**VALUE ENGINEERING SUMMARY  
OF  
CALLOWAY COUNTY  
KY 80  
MURRAY-MAYFIELD ROAD  
SECTION III**

**APRIL 26-30, 1999**

PROJECT: **FD04 018 8518 014 D SEC III**  
LOCATION **Calloway County**  
STUDY DATE: **4/26/99 thru 4/29/99**

IDENTIFICATION NUMBER: **Proposal 1 - Team 5**  
FUNCTION OF COMPONENT BEING CHANGED: **Water Crossing**  
DESCRIPTIVE TITLE OF RECOMMENDATION:  
**Combining 4 proposed structures into 2 structures**

SCALE 1:500  
STA 501+400 TO STA 501+800

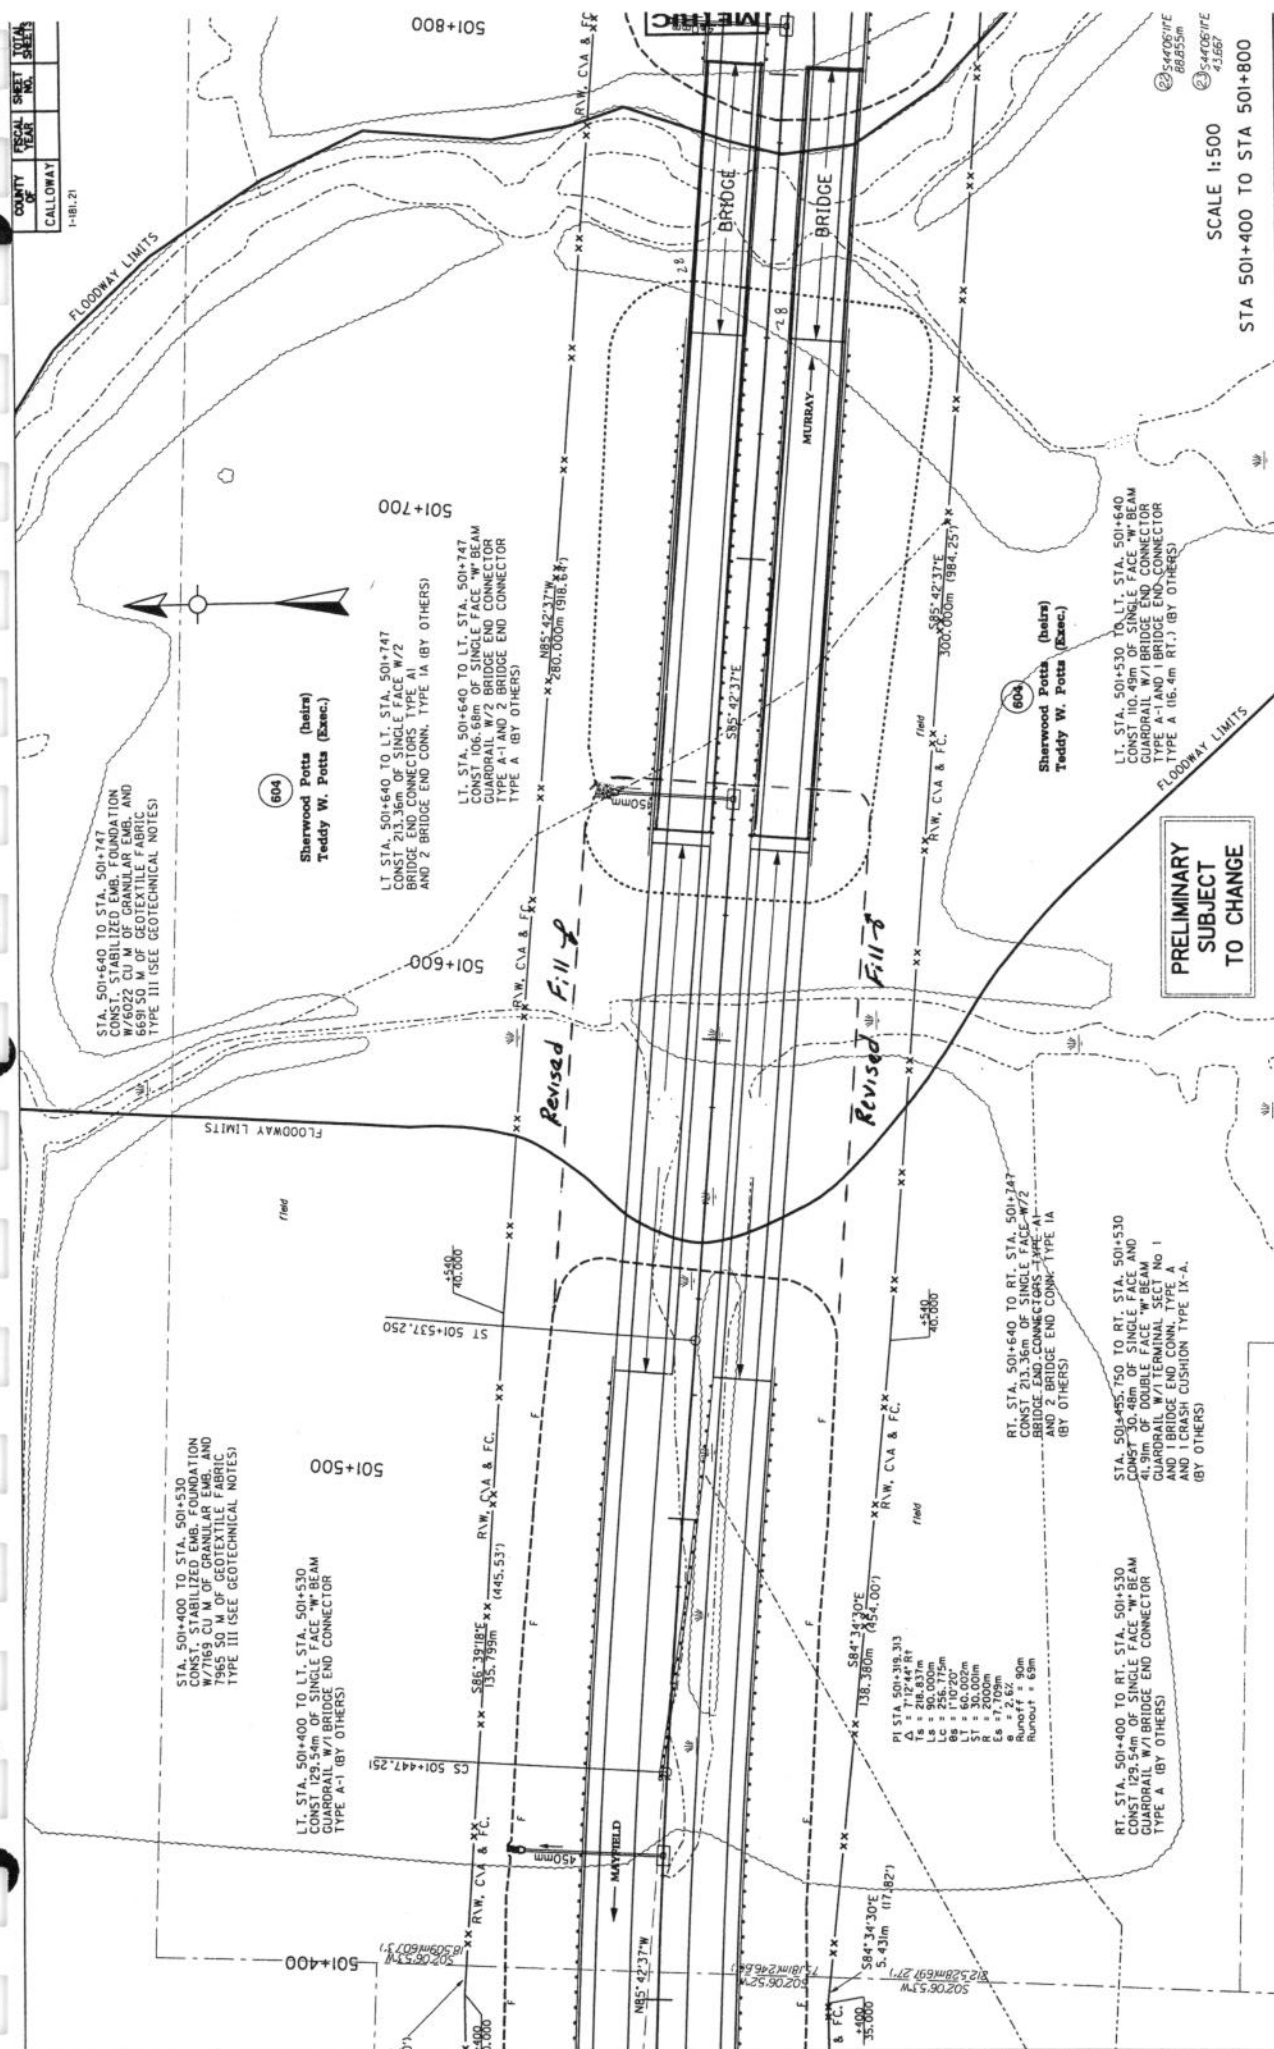
**Two things are proposed in this recommendation. The first is to combine the 55m structure spanning the West Fork of Clark River and the 110 m structure spanning the floodway of West Fork of Clark River into one 165m structure that serves both functions. Using one structure would eliminate 4 endbents, saving on cost, construction time, and maintenance.**

**The second proposal is using larger beams to span longer lengths. The original design uses spans of 27m to 35m and the recommendation is to use spans of 41 m. This would eliminate 4 piers; however, larger beams are required. After investigation, it is more economical to use the larger beams.**

**Combining the bridges eliminates discontinuity of the emb. construction needed to connect the two bridges. The proposed embankment is located in the floodway. The construction of this fill would be at a lower level of constructability and may have environmental impacts in the floodway.**

**Regardless of the acceptance of this proposal, it is strongly recommended that the bridges at sta. 501+530 be moved to 501+537.25, which will remove them from a spiral curve and place them in a tangent section.**

**Construct 2-165M, 4 span bridges crossing the West Fork of Clark River as well as providing back water relief for the floodplain.**

ORIGINAL DESIGN

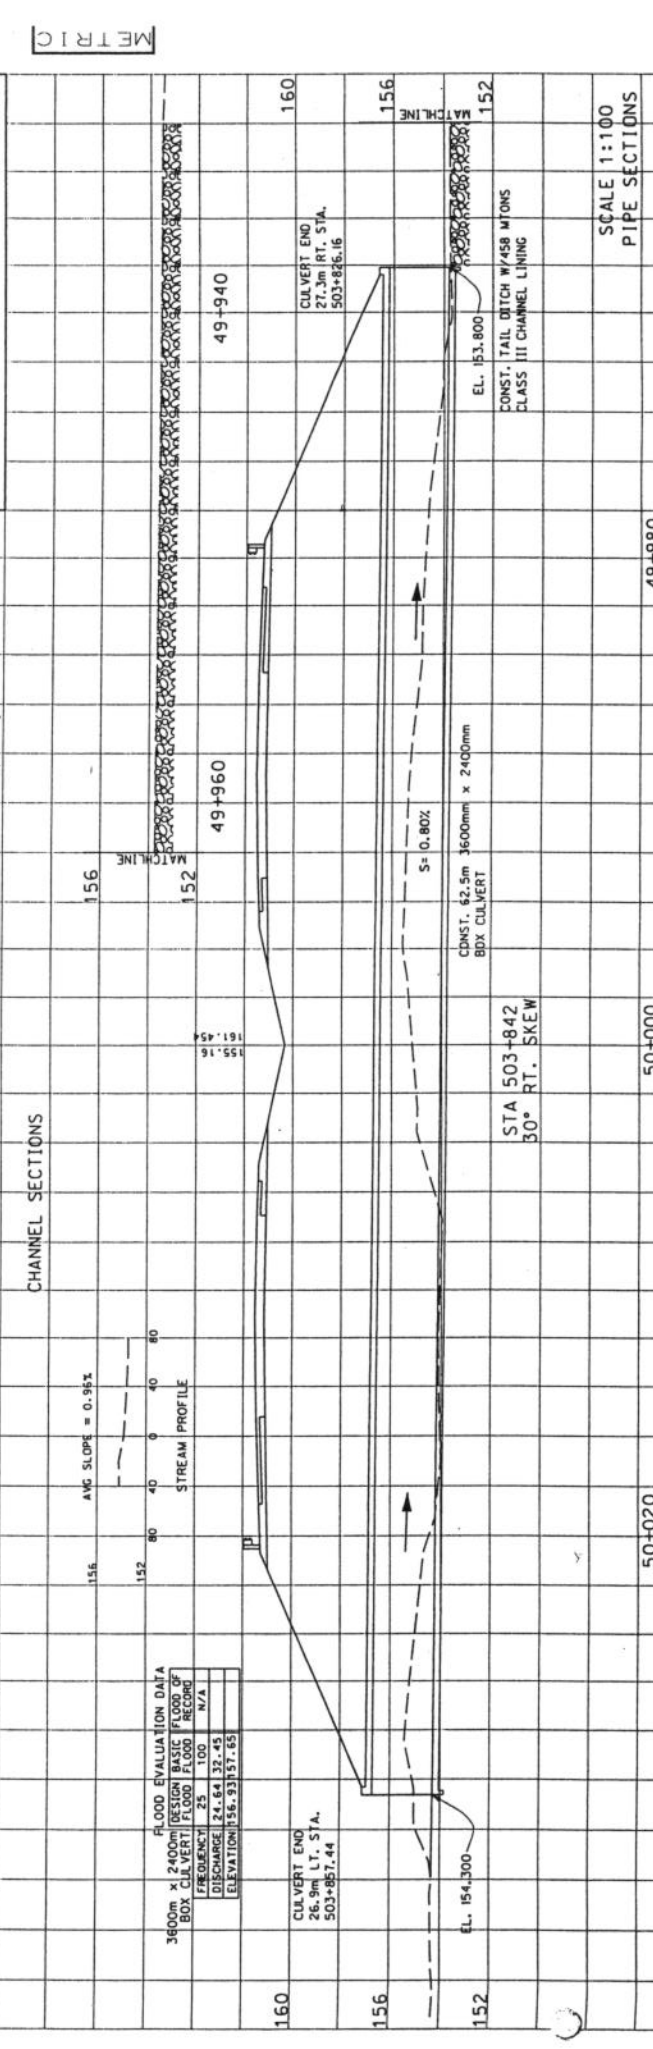
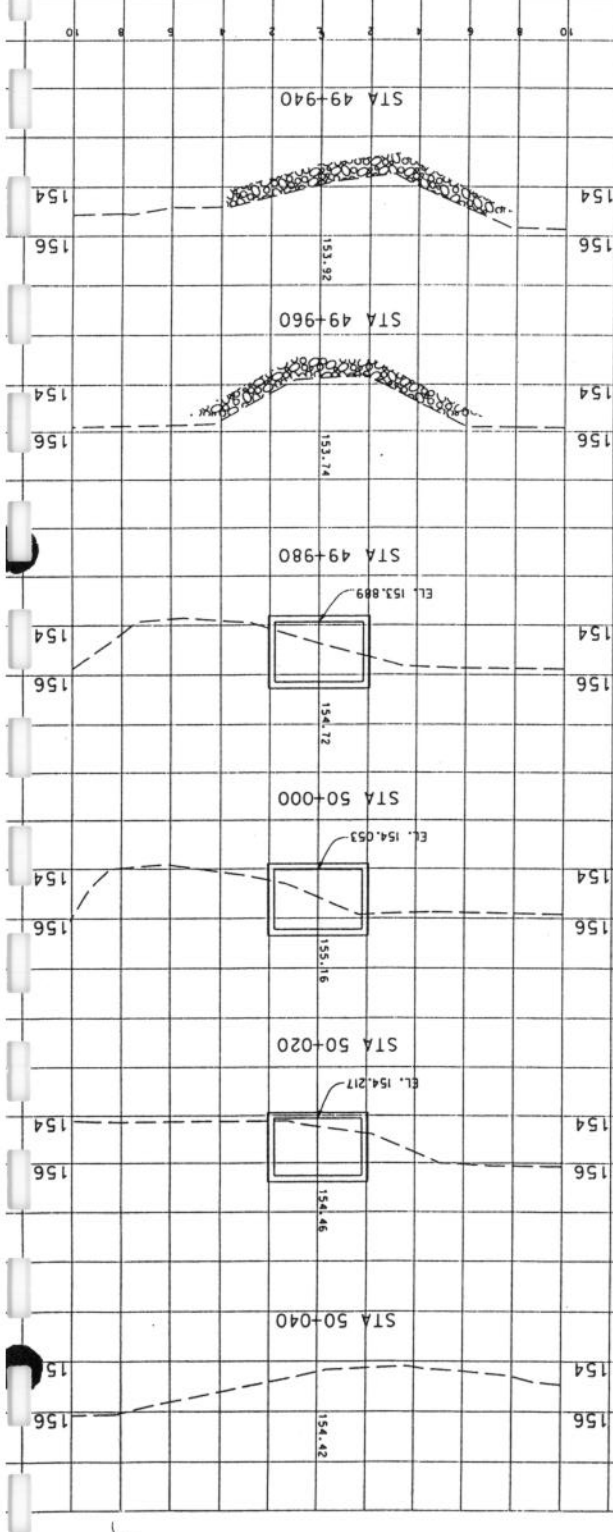
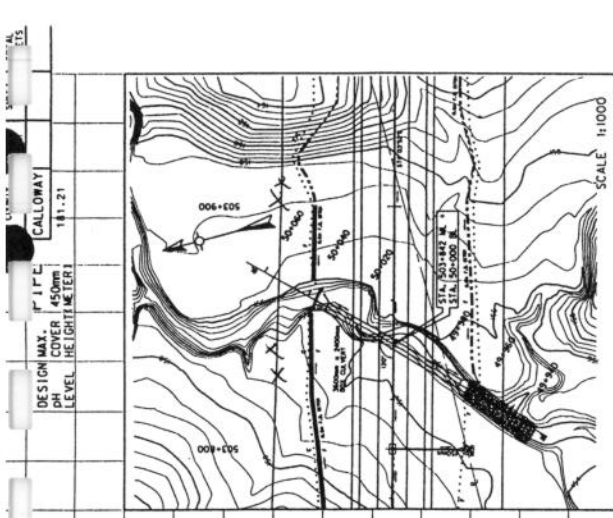
IDENTIFICATION NUMBER: **Proposal No. 2** **Team No. 5**  
FUNCTION OF COMPONENT BEING CHANGED: **Transport Water**  
DESCRIPTIVE TITLE OF RECOMMENDATION: **Change 3.6M x 2.4M Box Culvert**  
**@ Sta. 503+842 to 3.7M Bit. Coated CM Pipe**

**Construct 62.5 M of 3.6M x 2.4M Box Culvert @ Sta. 503+842**  
**@ 30 degree skew right.**

**Construct 55M of 3.7m Bit. Coat Corr. Metal Pipe @ Sta. 503+842**  
**@ 30 degree skew right.**

PROPOSED DESIGN

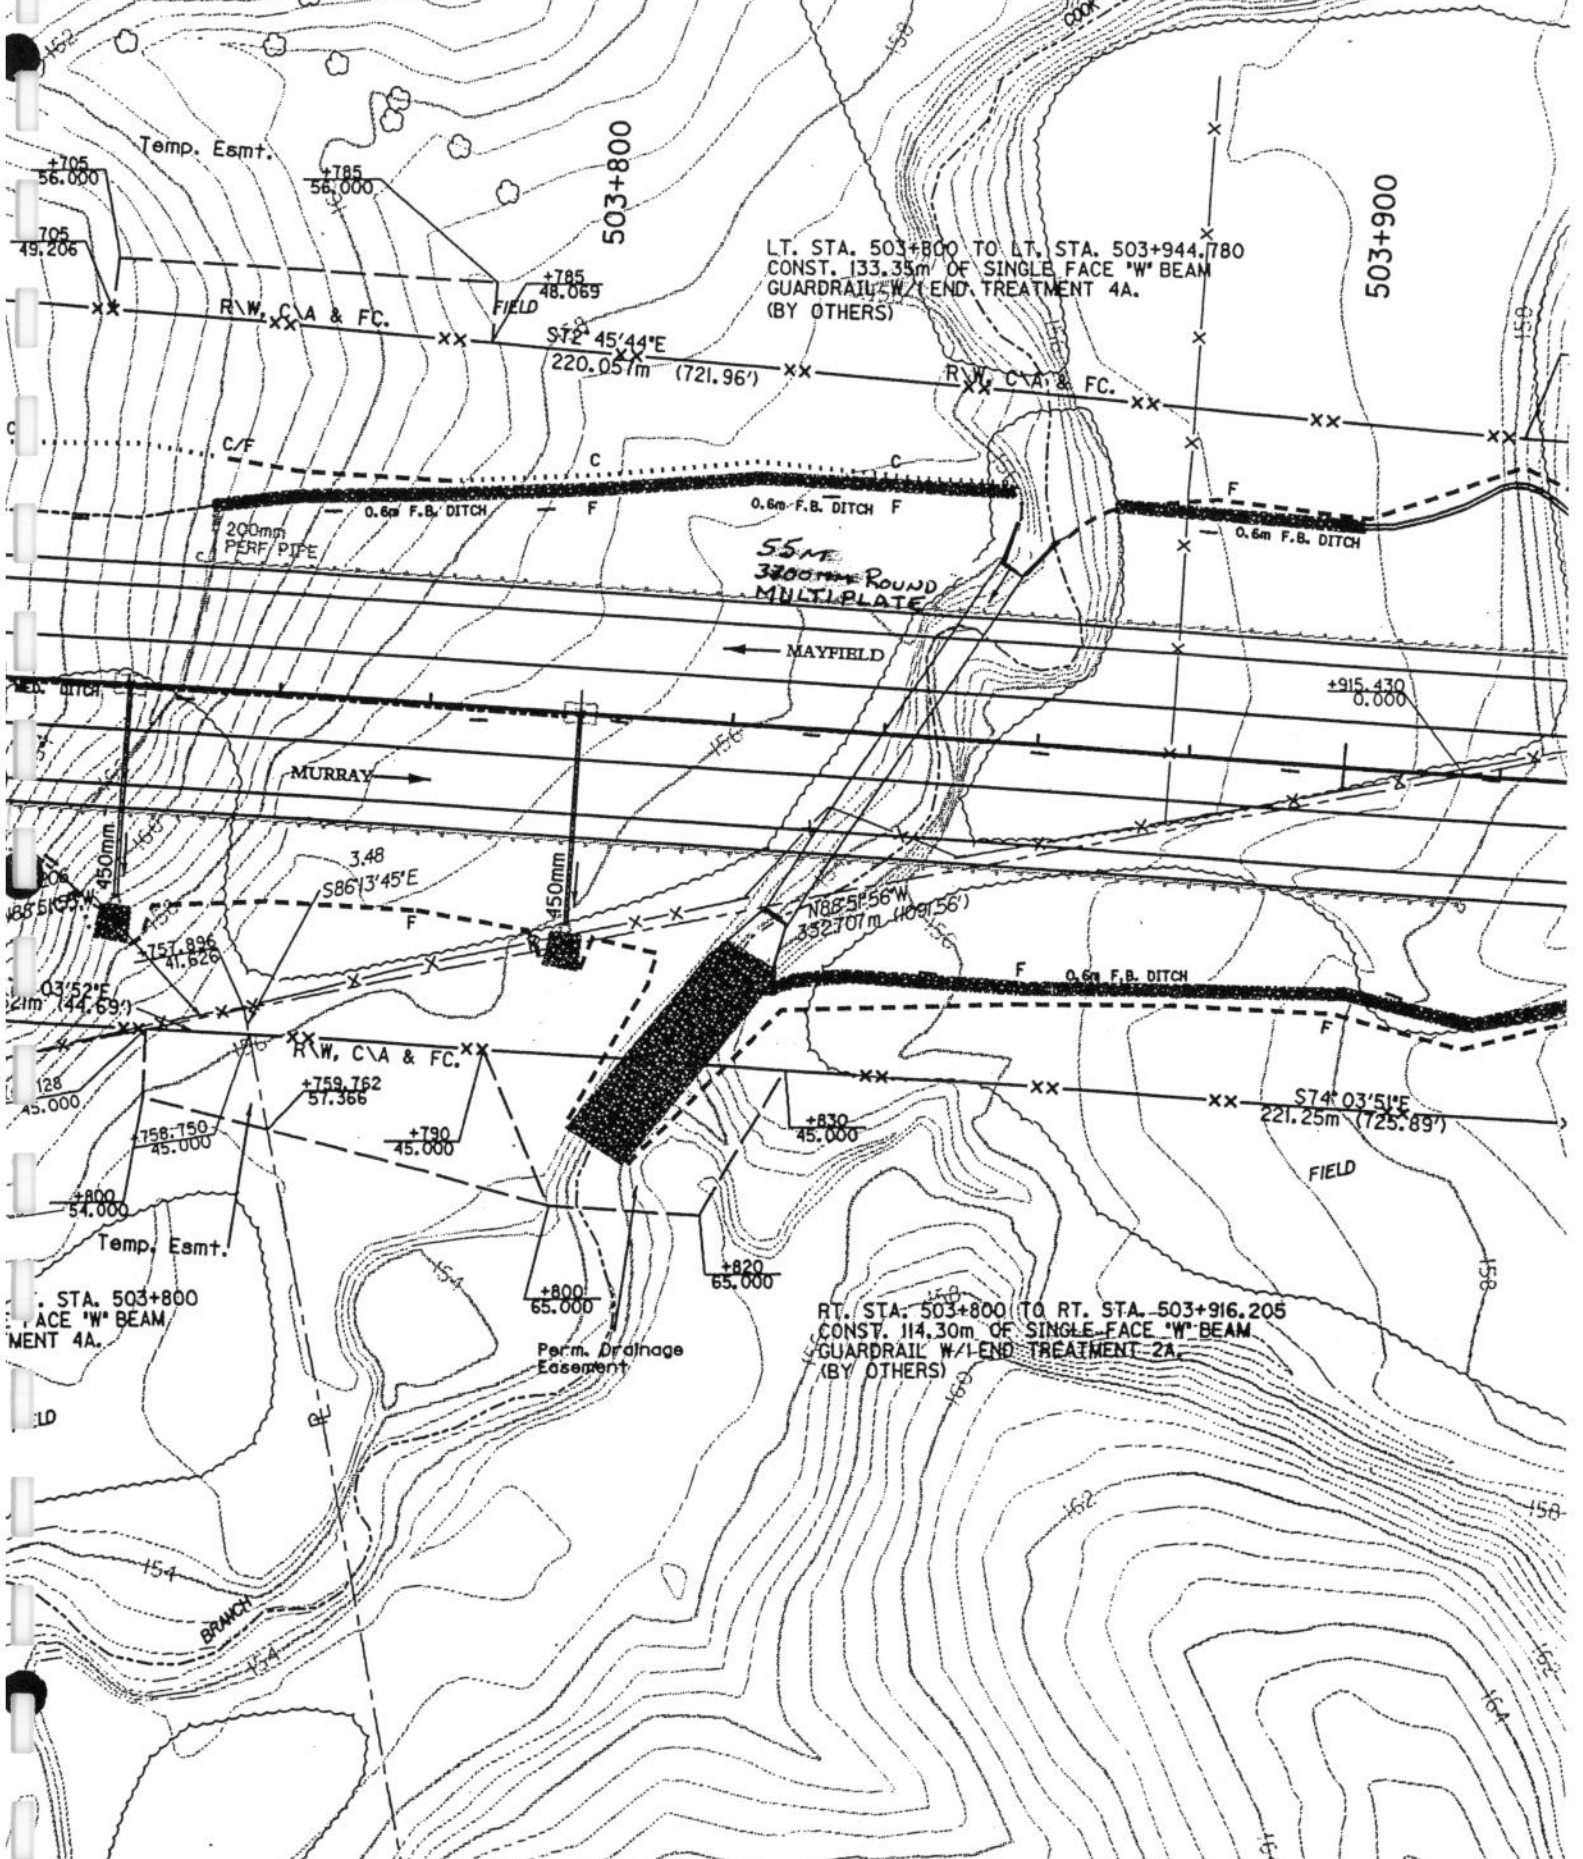
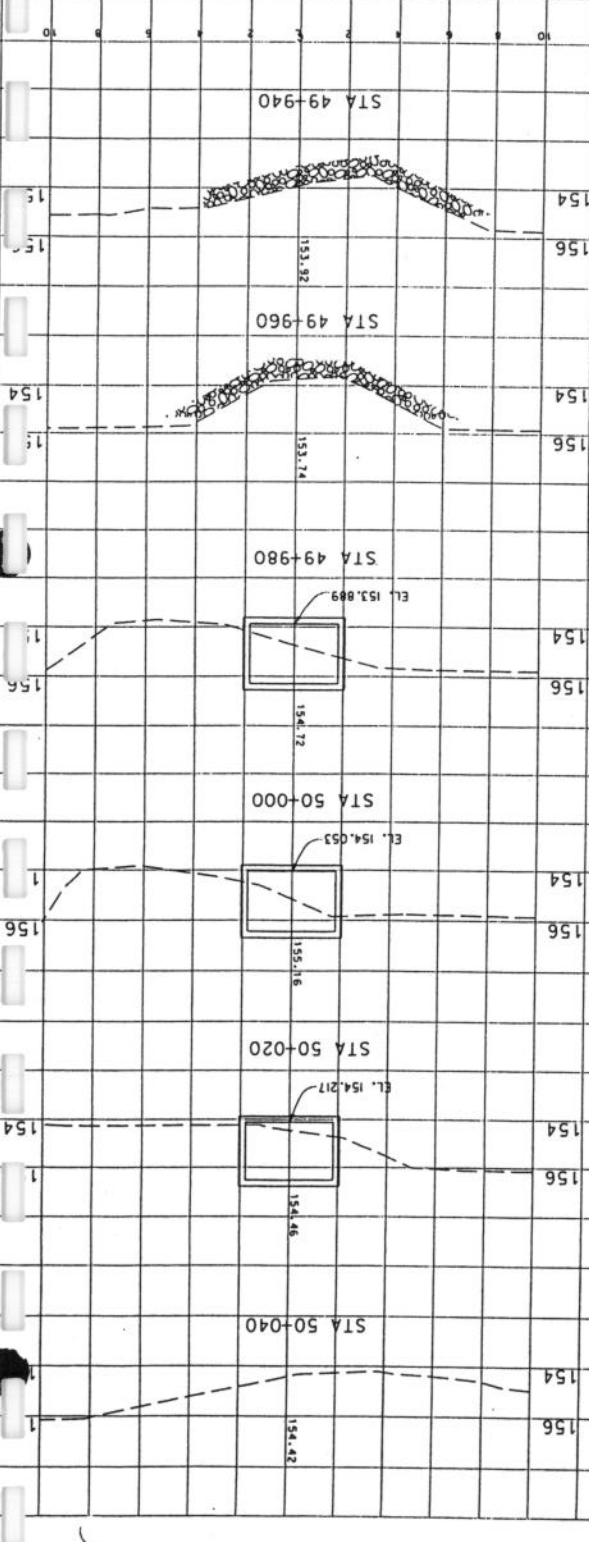
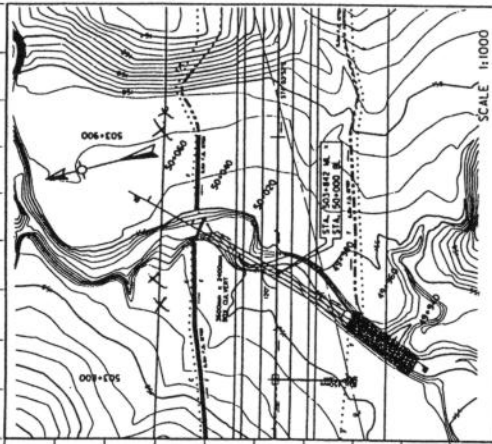
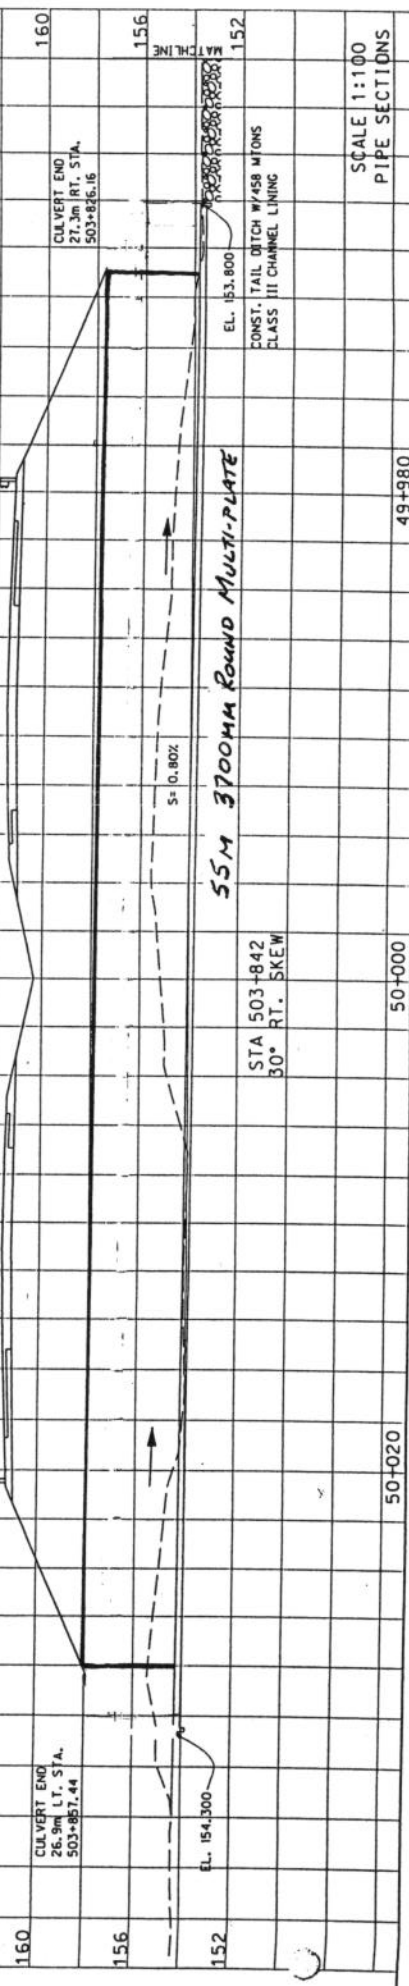
**The construction of the 3.7m BCCM pipe is an easier and faster operation than the construction of the 3.6M x 2.4M box culvert. The less time spent in the construction process results in lesser impacts to the environment, not to mention lower labor costs as well as faster completion of the project without compromising the integrity of the project.**
